Our Case Number: ACP-324610-26

Re: Hodson Bay Waterfront Park Project
Hodson Bay, Townland of Barrymore, Co. Roscommon

Planning Appeal Online Observation

Site Layout Plan

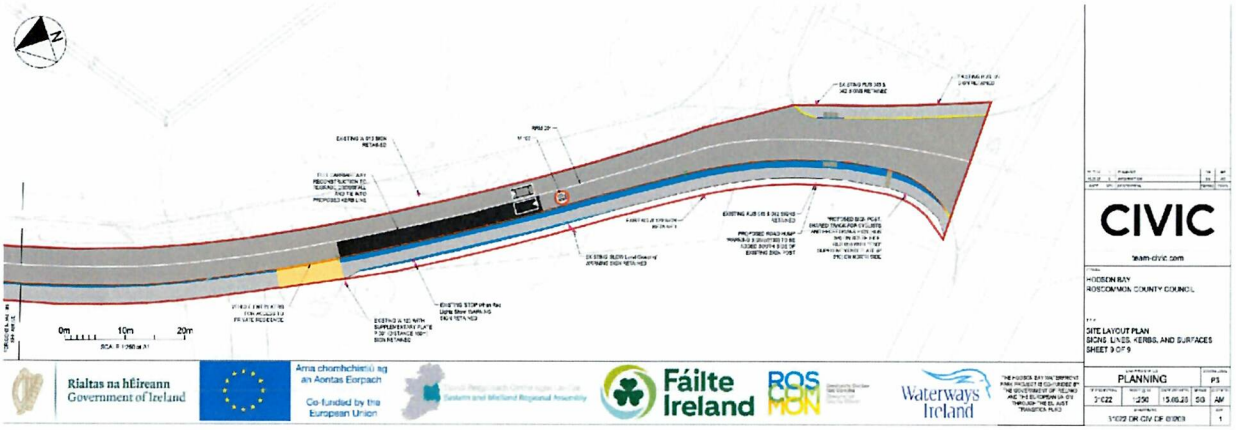
On review of the proposed cycleway and modifications to the Hodson Bay road referenced on 31022-dr-civ-ce-00201-00209_hodson-bay_signs-lines-kerbs-and-surfaces_v1.pdf
I would like to point out that the existing access to my property does not appear in the site layout plan.

The proposed junction does not show a dropped kerb access to my property as is the case today. See photo below of current dropped kerb/access.

Furthermore the proposed signpost referenced in the site layout plan is in the direct path of my access.

Photo of existing dropped kerb access
Acces to my land must be maintained. Appreciate if your design can be amended and sent to me for a review.
